Part 5 Application **ACCESS REPORT**

Reference Number: 22477

LAHC 69 Trafalgar St & 2-6 Gover St,
Peakhurst, NSW

Executive Summary and Design Compliance Statement

[Image description: Plan of Level 00 above shows the provision of Accessible parking spaces]

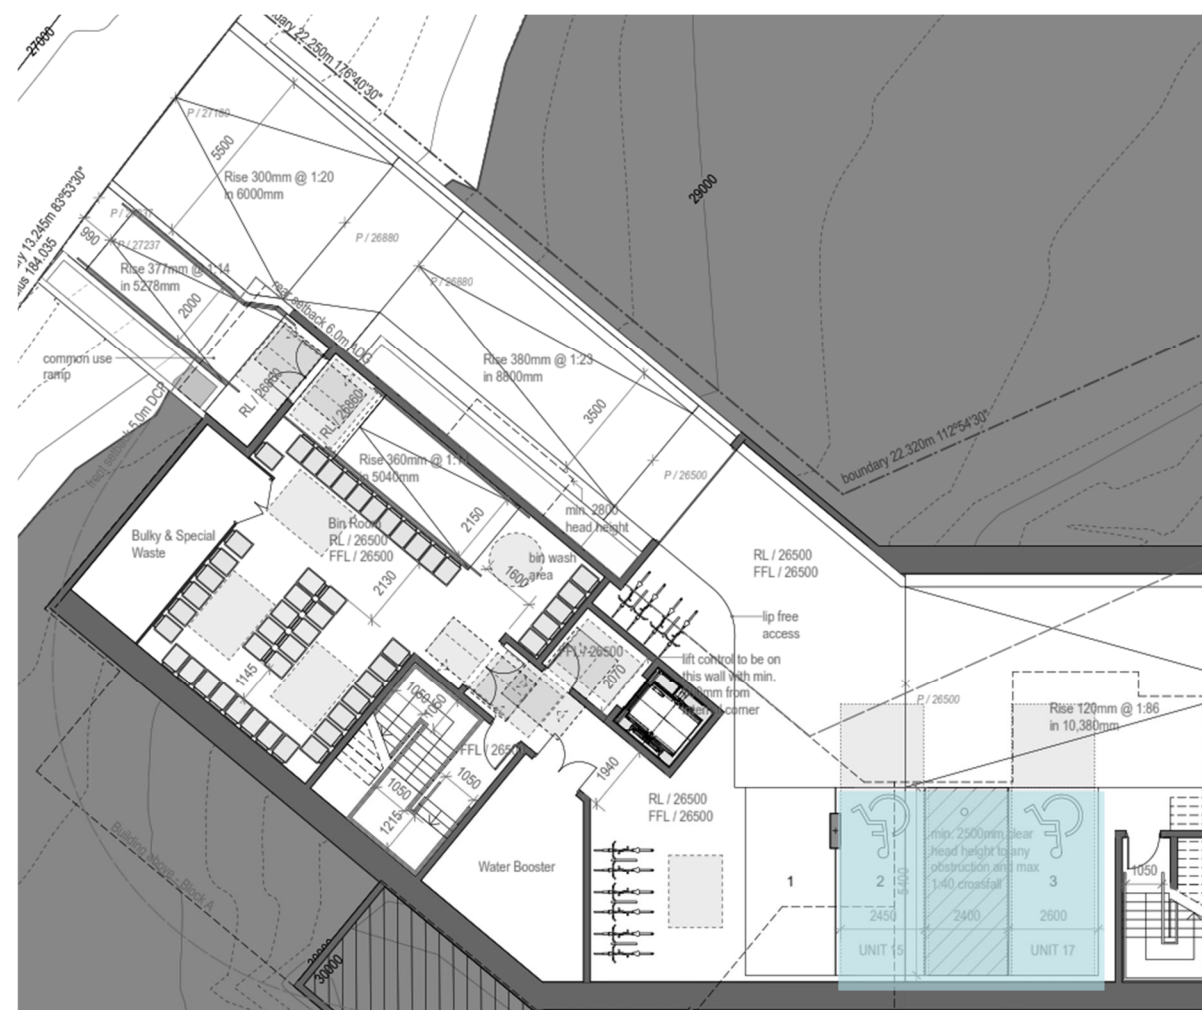
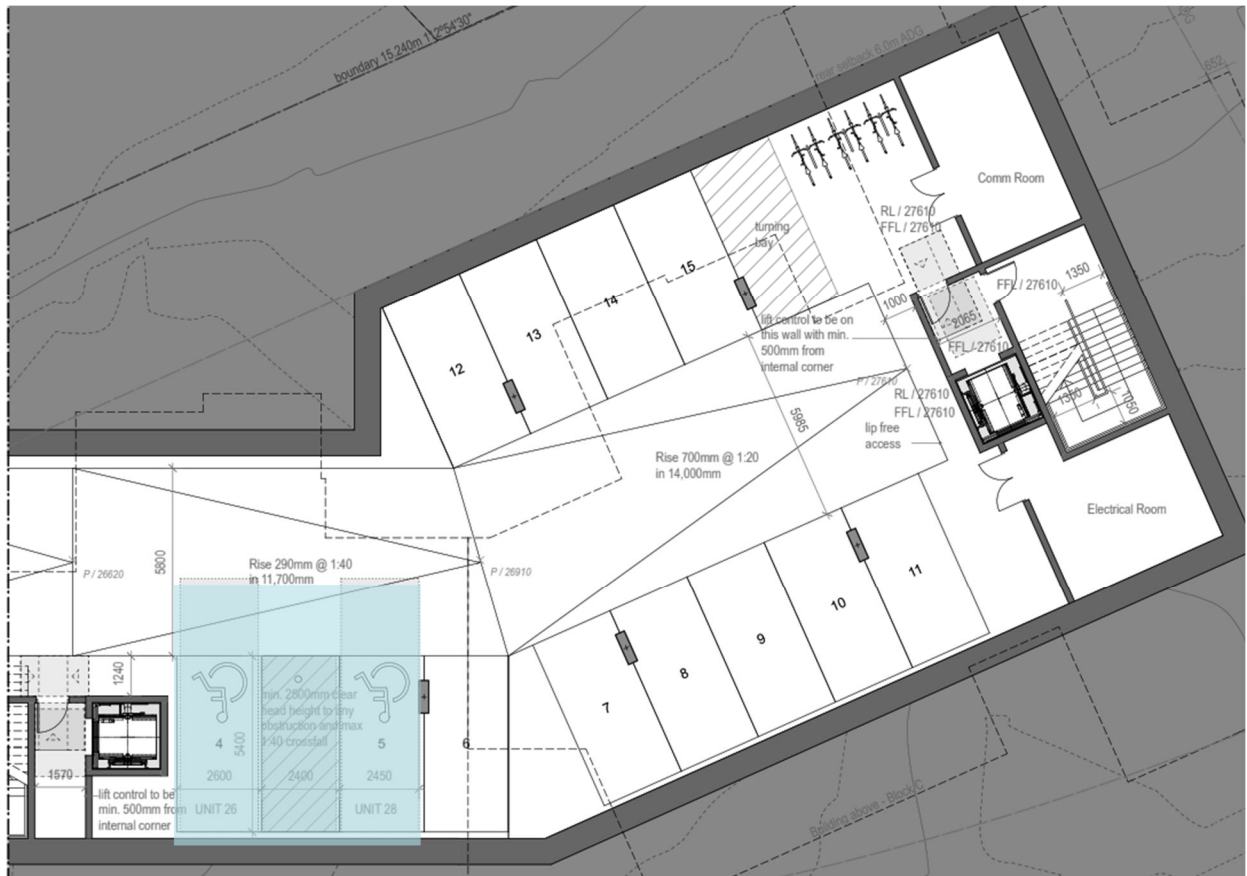
Georges River Council requires provision of 10% Adaptable units in the development.

Development has total number of 33 units. $10\% \text{ of } 33 = 3.3 = 4$ required Adaptable units.

However, plans show provision of 6 adaptable units and therefore 6 accessible spaces are required to be provided.

Therefore, 4 accessible / (AS4299 compliant) carparking spaces are required for the residential component of the development.

4 Accessible car parking spaces have been provided in development.

One accessible parking space is required to be allocated to each of the Adaptable units.

Units 1,2,3

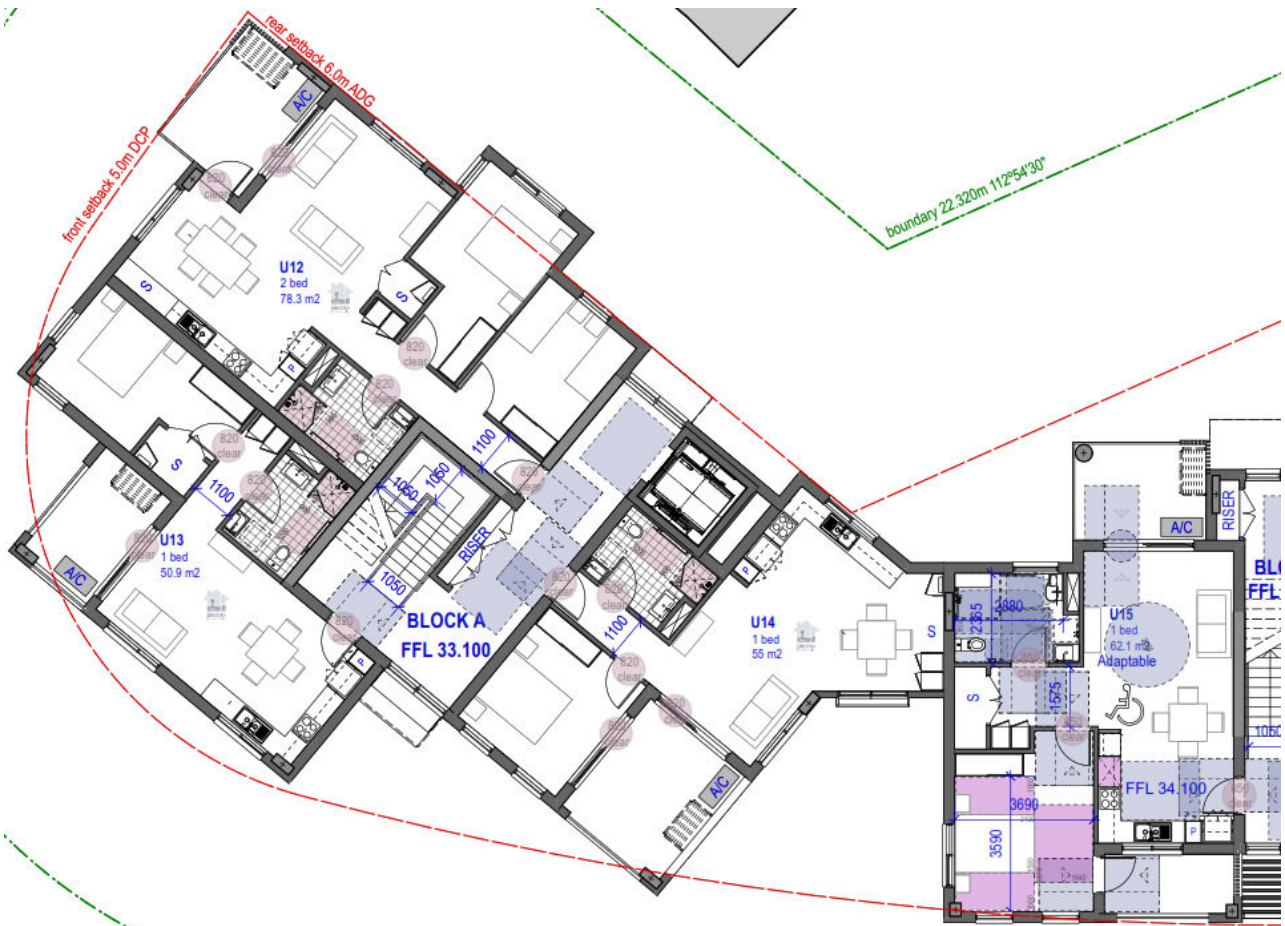
In addition to the adaptable units provided the following 27 units, **Units 1, 2, 3, 5, 7, 8, 9, 10, 11, 12, 13, 14, 16, 18, 19, 20, 21, 22, 23, 24, 25, 27, 29, 30, 31, 32 & 33** are capable of providing compliance with the features of Silver level of Livable Housing Guidelines as noted in the table below.
